Project Name: York Region Admin., Package D Renovation

CONSULTANTS RFI NO: TC24-114-23-X

REFERENCE: [Ground, 2nd & 3rd Floor Chilled Water Main](#)

Ground, 2nd & 3rd floor chilled water main

1st Floor

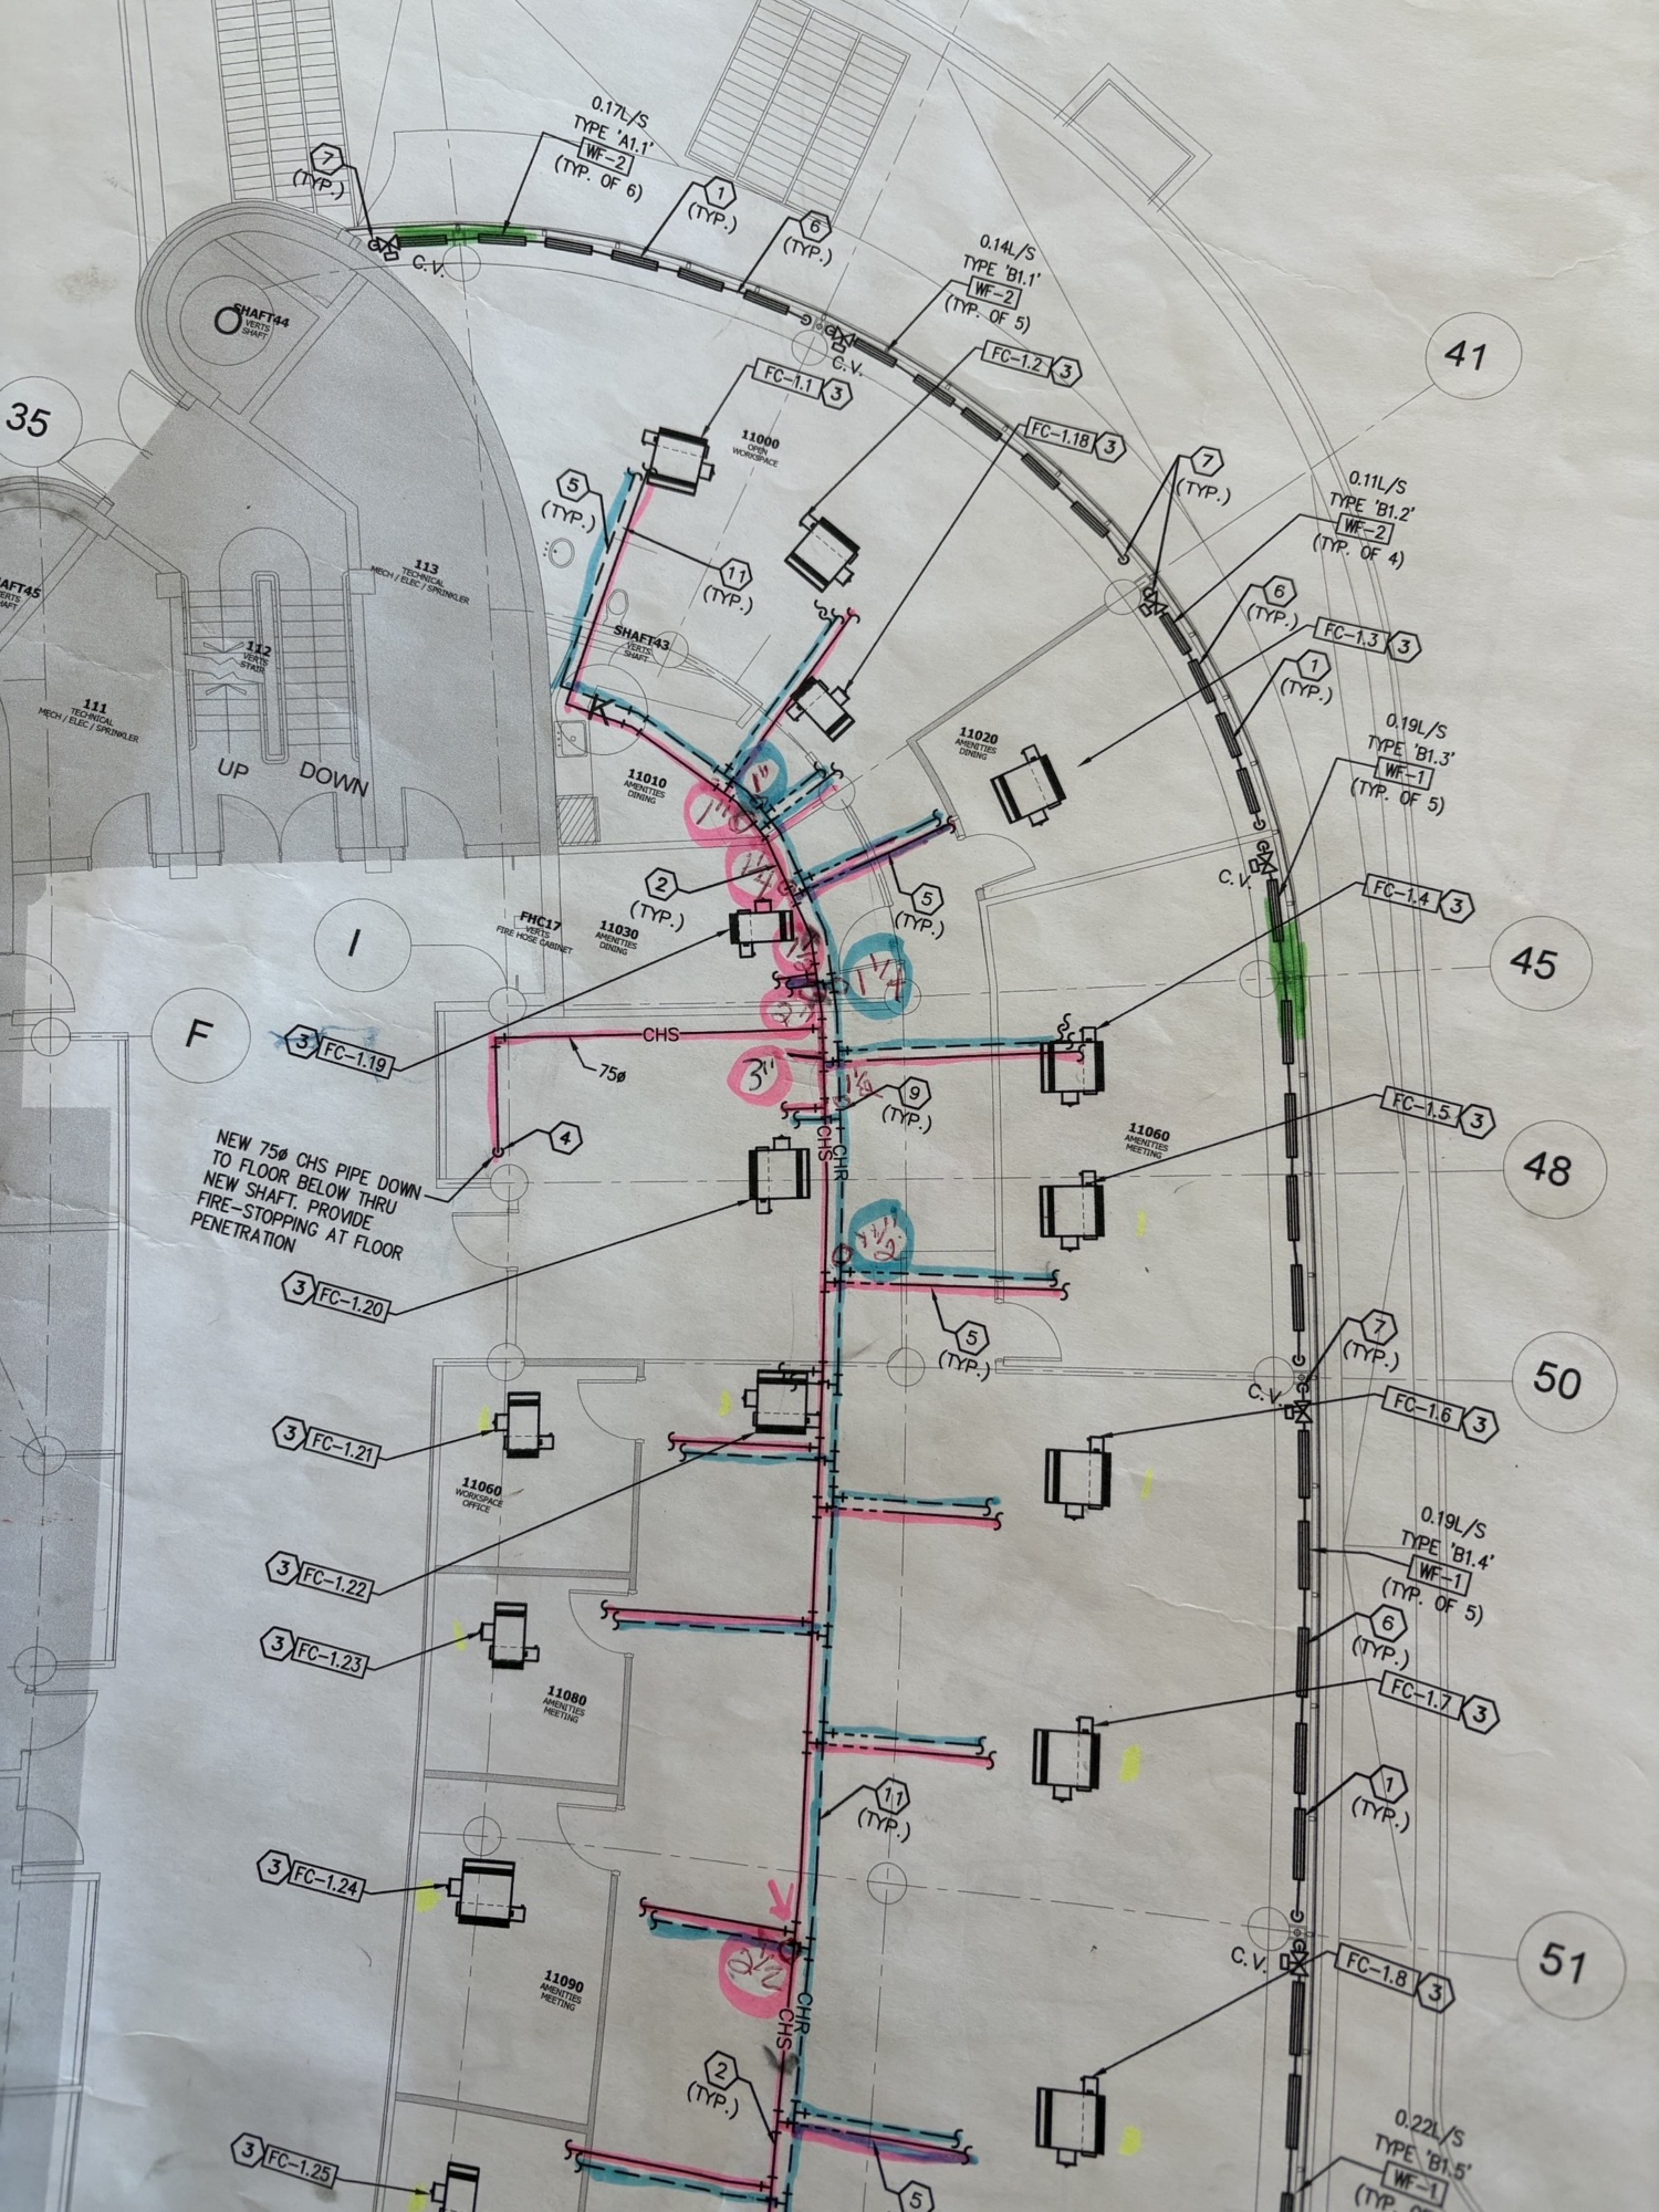
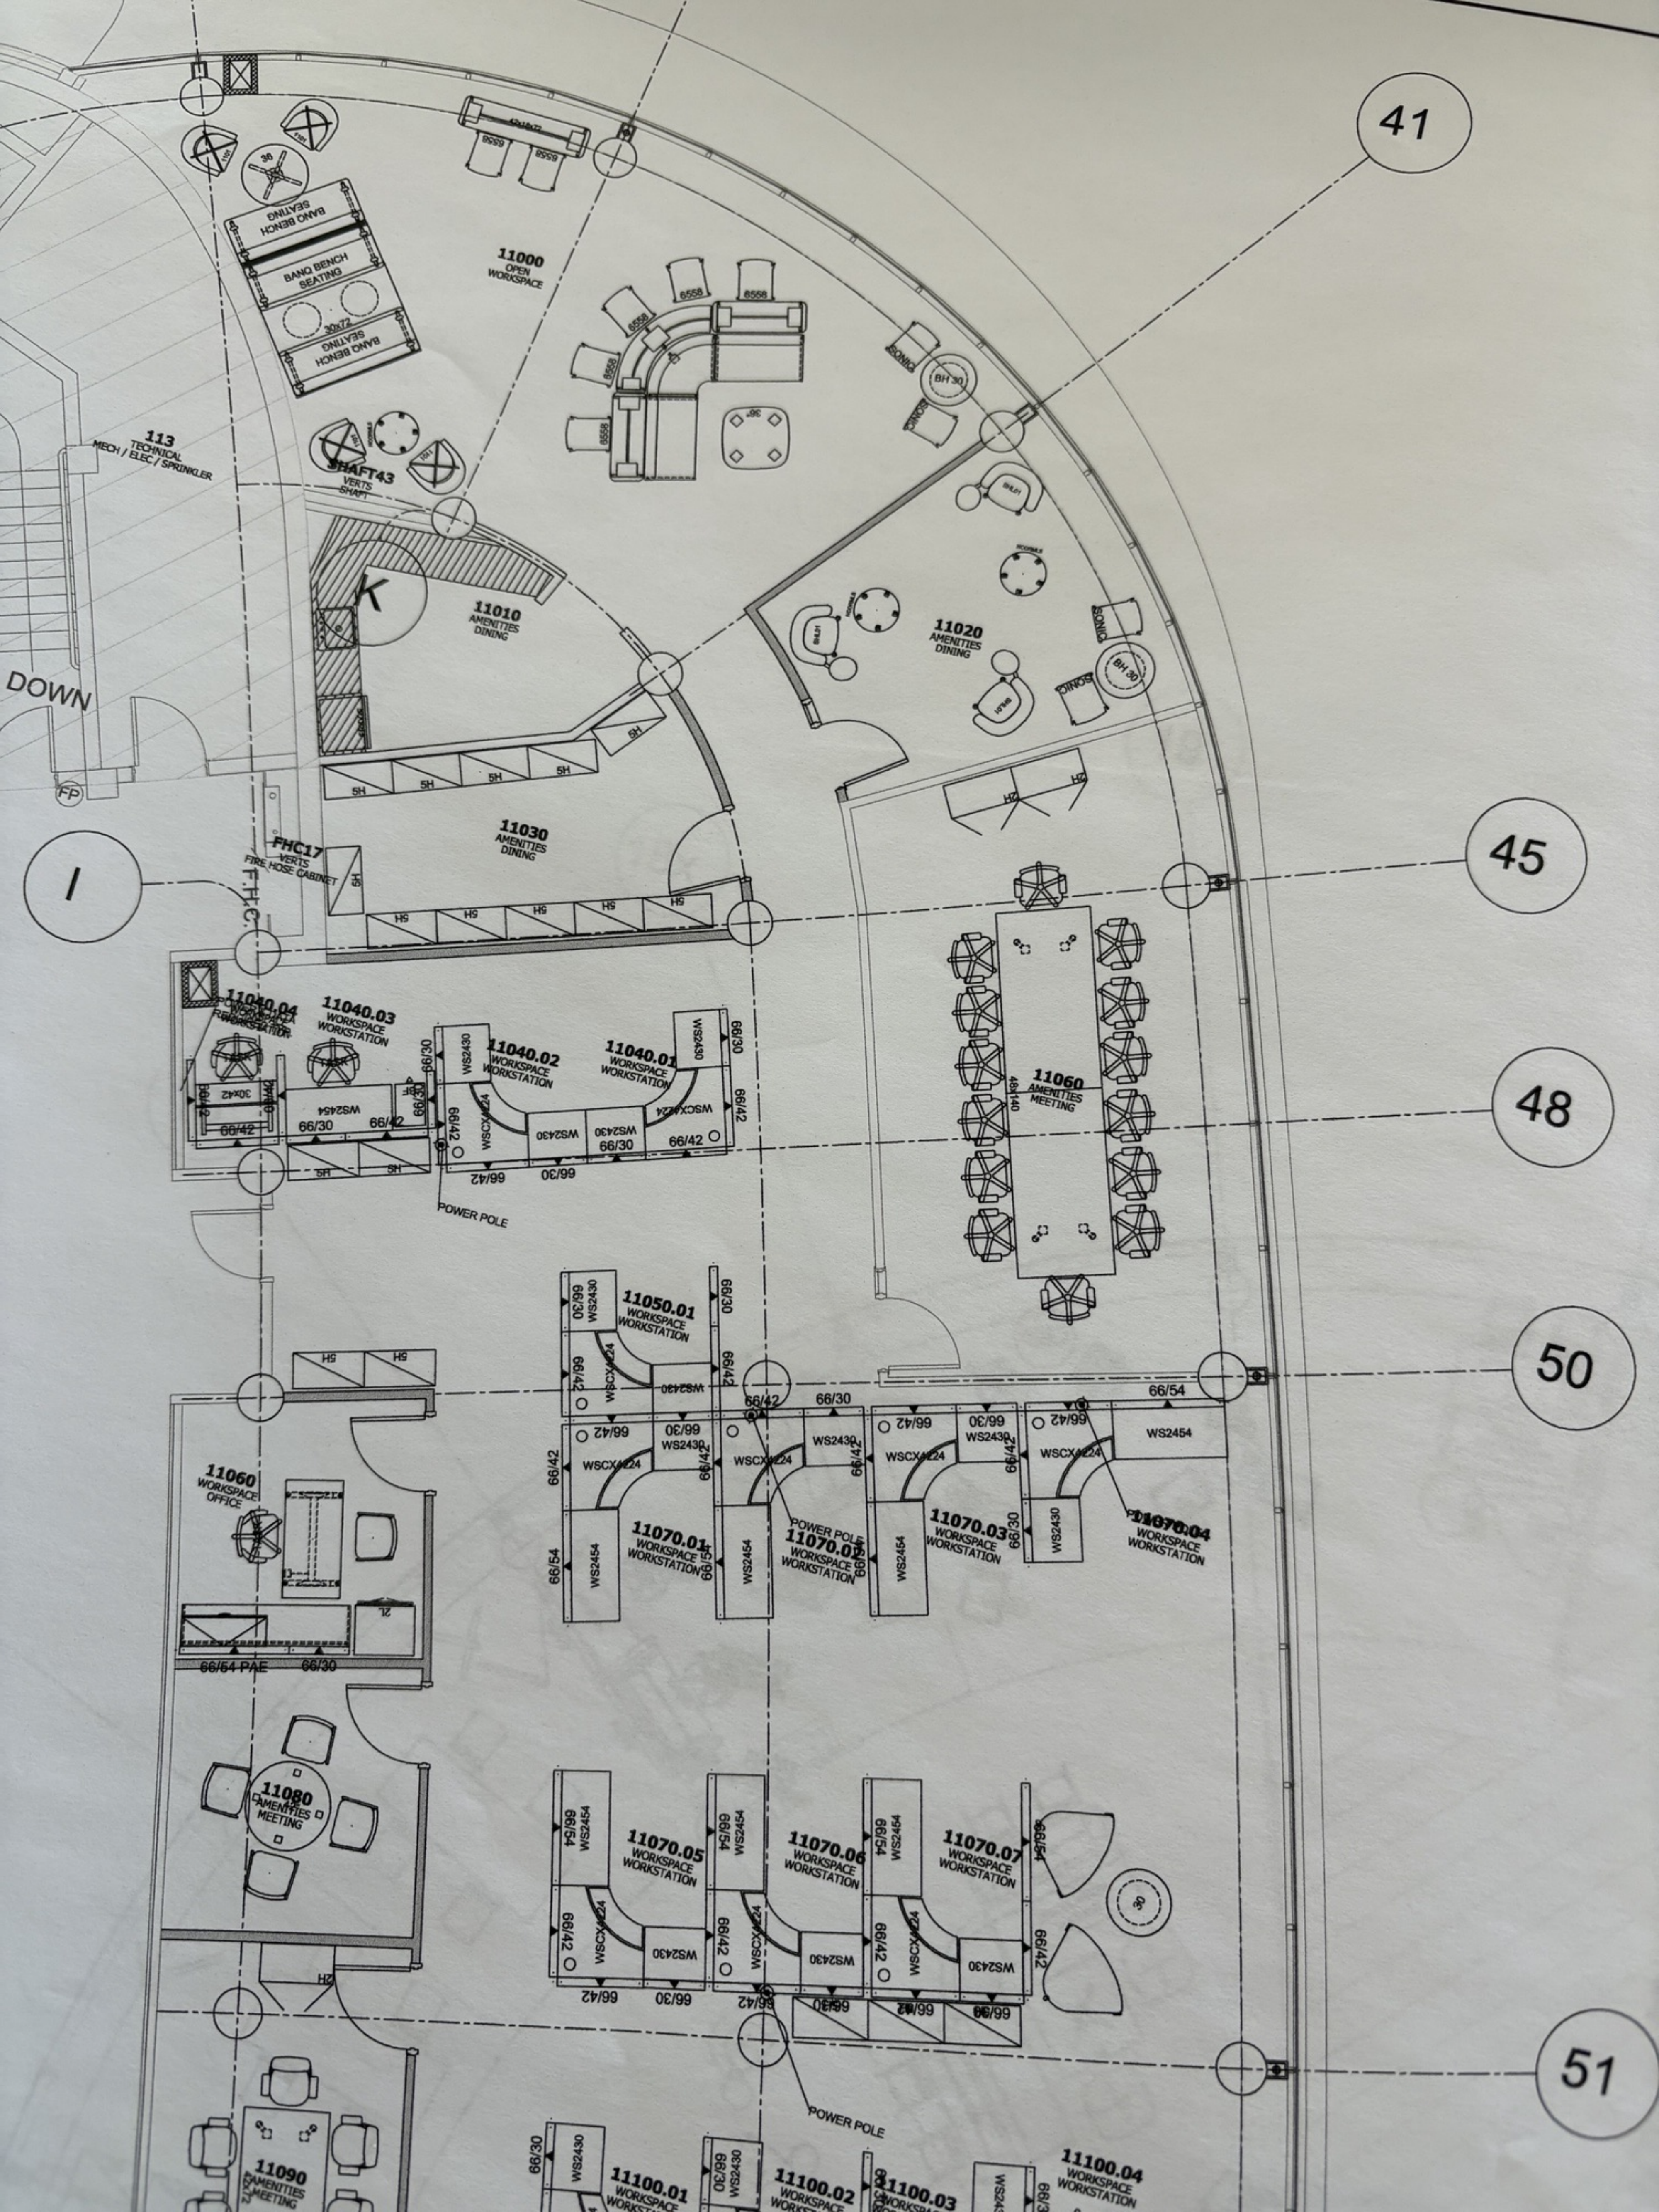
Please refer to attached drawings for alternate chilled water riser locations. Please confirm which location is suitable for architect's and structural consultant's review and approval.
